S-TYPE

S100-05

TECHNICAL BULLETIN

**S-TYPE Enhancement Program –
Service Action S120**

ILLUSTRATION 2

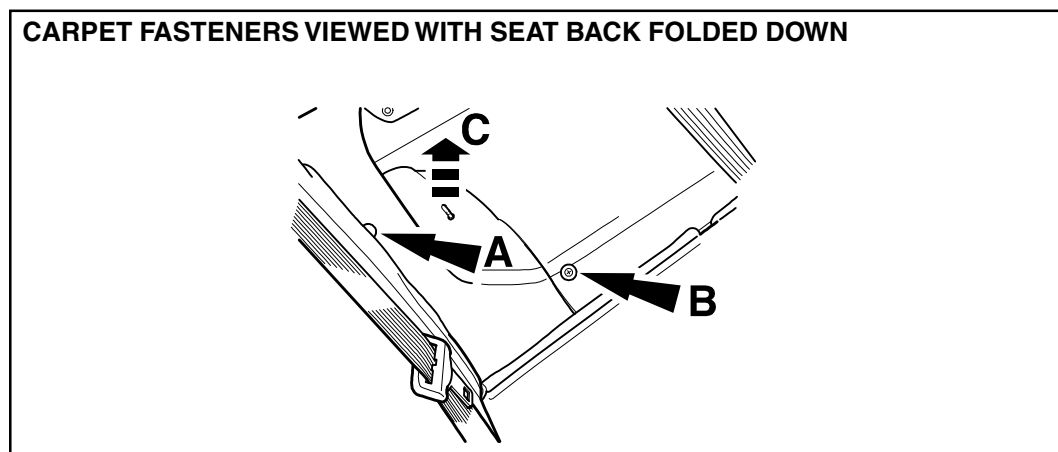
2. Working through the right side rear door, pry out the fir-tree fastener 'A' in Illustration 2. Release (1/4 turn) the fastener 'B' and pry it from the carpet of the luggage compartment. This illustration shows the carpet fasteners arrowed as 'A' and 'B' on the right hand side of the vehicle, as viewed through the right hand rear door, looking rearwards. Arrow 'C' indicates that the side carpet must first be raised clear of the hook before it can be released and repositioned towards the right hand side of the luggage compartment. Left side of vehicle is a mirror-image of this view.
3. Via the left rear door, remove the similar fasteners on the opposite side of the vehicle.
4. Roll the center section of the carpet rearwards into the luggage compartment.

5. On one side, raise the side carpet clear of the projecting hook in the luggage compartment floor ('C', Illustration 2). Release the side carpet from the trim against the side of the vehicle until the front portion can be rolled clear sufficiently to provide access to the areas shown in Illustrations 3 and 4. Repeat for the opposite side of the vehicle.

ILLUSTRATION 3

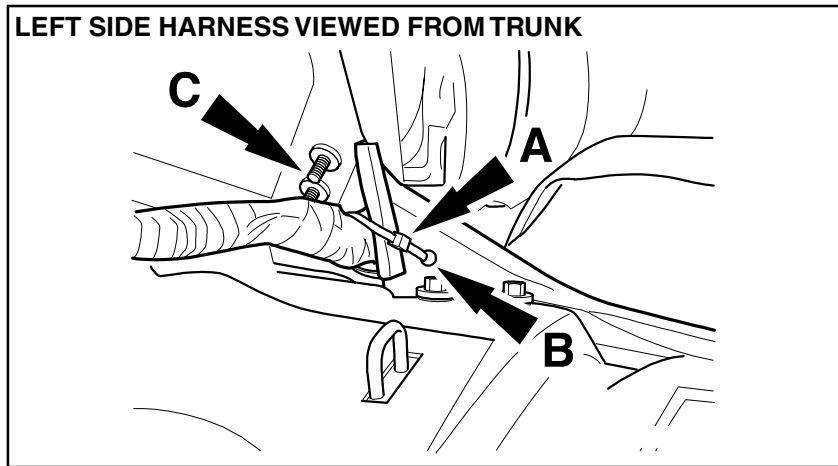
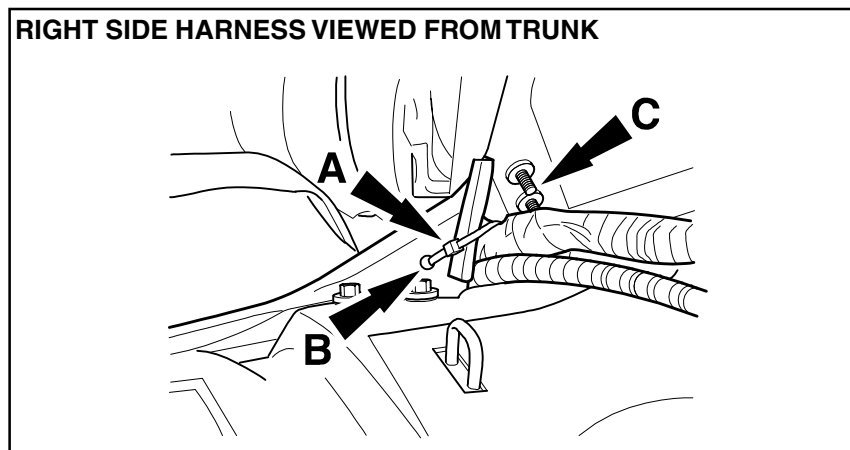
6. On the left side, pass a tie-strap 'A' through the hole 'B' in the body stiffener plate and then around the main body harness. Tighten the tie-strap so that the body harness is retained away from the threads of the two securing bolts 'C', and cannot become chafed on these bolts. Cut off the excess length of tie-strap.
7. Repeat item 6 at the right side, noting that on this side the tie-strap passes around the main battery feed cable in addition to the body harness.
8. Reinstall the portions of the side carpet, taking care to tuck them under the trim at the side of the vehicle to restore the original appearance and to permit the fir-tree fasteners to be reinstalled in their original locations without any distortion of the side carpets. Roll the center section of the carpet forward to its correct location before installing the fir-tree fasteners shown at 'B' in illustration 2.

ILLUSTRATION 5

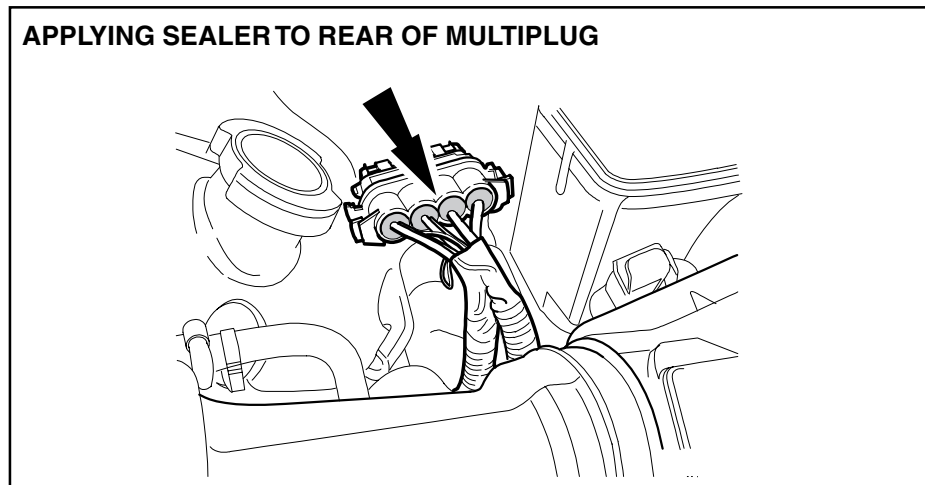
8. Apply a suitable cleaning fluid to the rear face of the harness multiplug; blow with an airline until completely dry.
9. Using a tube of polyurethane-based sealer, trim the tip of the nozzle to allow sealer to be injected into the rear face of the harness multiplug so as to seal the entry of the wiring into the multiplug. **It is necessary to use a polyurethane-based sealer and not a silicone-based sealer due to sealing abilities of the polyurethane.** Fill each of the 4 large cells of the plug until the sealer is flush with the rear face of the plug and adhering to the wiring (Illustration 5).

10. If possible, allow time for the sealer to partly-dry or cure before reinstalling the multiplug to the module and correctly locating the harness into its retaining clips. Where convenient, allow drying or curing to occur overnight.
11. Reinstall the cable clips to retain the harness. Remove the fender covers and close the hood.

ILLUSTRATION 6

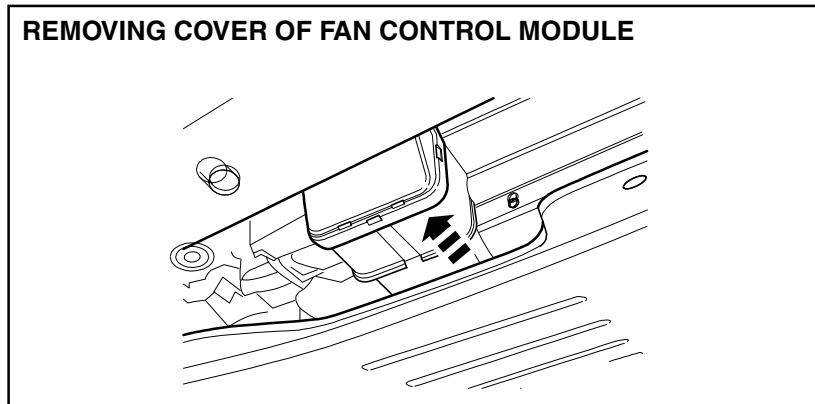
14. Release the 5 plastic tangs which retain the cover of the Fan Control Module and remove the cover, (Illustration 6).
15. Remove the retaining bolt from the rear of the module (Illustration 7). Move the module upwards until there is sufficient clearance for it to be removed. Install the replacement unit by a reversal of the above procedure.

ILLUSTRATION 8

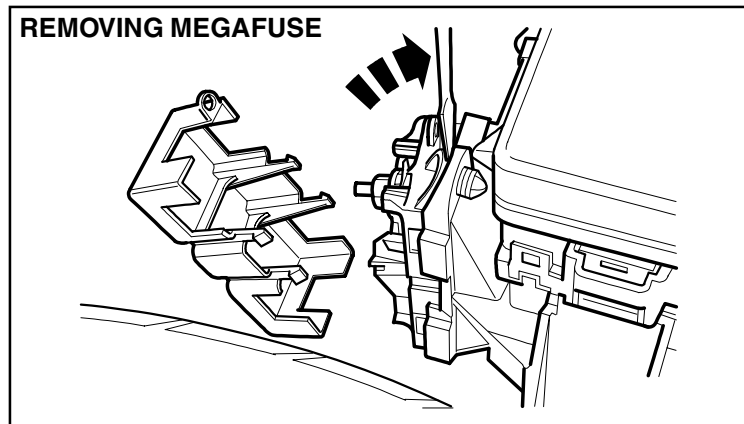
1. Disconnect the battery. Remove the spare wheel and jack to improve access.
2. Locate the Megafuse which is attached to the front face (nearest the rear seat) of the Rear Power Distribution Box, on the right hand side of the luggage compartment.
3. Release and remove the cover - located by 4 tangs (Illustration 8).

4. Remove the terminal nuts and disconnect the power leads. **Note their locations to assist in reassembly.**
5. Carefully pry the Megafuse away from the Rear Power Distribution Box - it is retained by captive 'fir tree' fasteners. Discard the old megafuse.
6. Install the new megafuse part no. XR8 12486. Torque the terminal nuts to 9.5 Nm. Reassemble in reverse order.
7. Reset the clock.
